**DEPARTMENT OF TRANSPORTATION**

**Federal Motor Vehicle Safety Standards; Electric-Powered Vehicles: Electrolyte Spillage and Electrical Shock Protection**

**ACTION:** Final rule.

**Figure 7b. S4, S5.3, S5.4.1.3, and S5.4.1.4 Jointed test finger IPXXB**

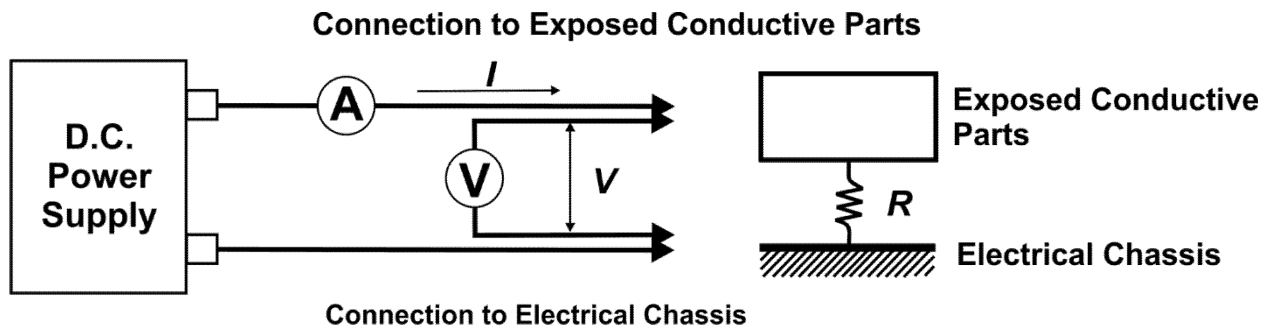
We make a minor correction to Figure 7b and clarify Figure 8.

The proposal provided specifications of the IPXXB probe in Figure 7b of the regulatory text. The Alliance and Global note errors in the specification for R2 and R4. The agency has corrected the errors in Figure 7b.

The Alliance and Global provide an improved Figure 8 in which the text is clearer than the NPRM’s Figure 8. The agency has included the new figure in FMVSS No. 305.
